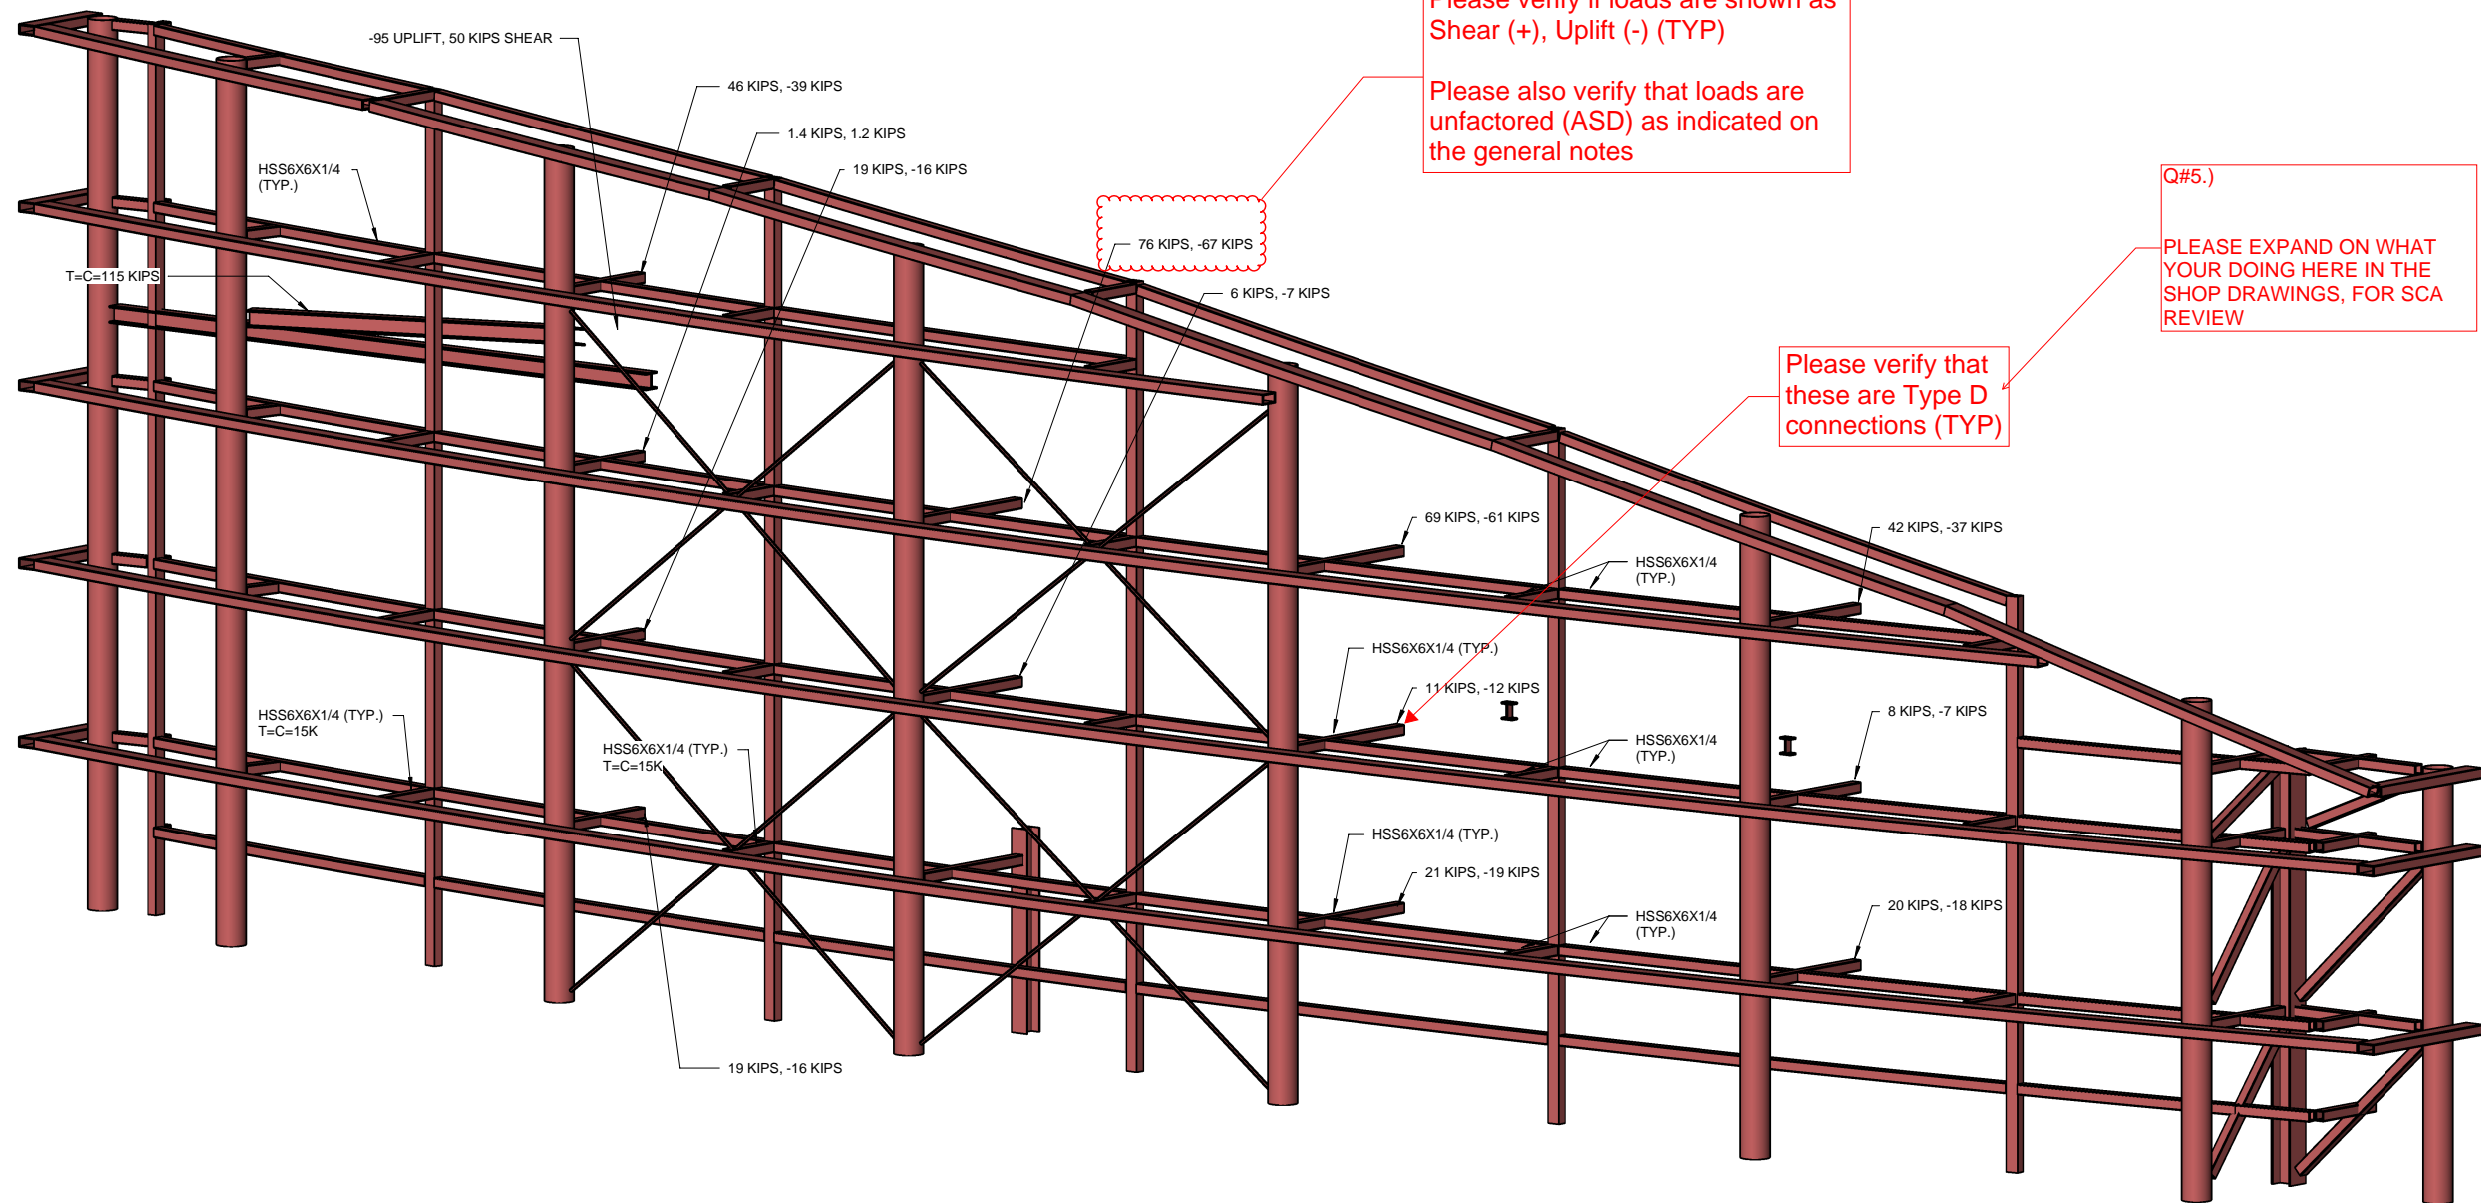
Please verify if loads are shown as
Shear (+), Uplift (-) (TYP)

Please also verify that loads are
unfactored (ASD) as indicated on
the general notes

Please verify that
these are Type D
connections (TYP)

Q#5.)
PLEASE EXPAND ON WHAT
YOUR DOING HERE IN THE
SHOP DRAWINGS, FOR SCA
REVIEW

Q#4.0
CORRECT.
YES UNFACTORED.
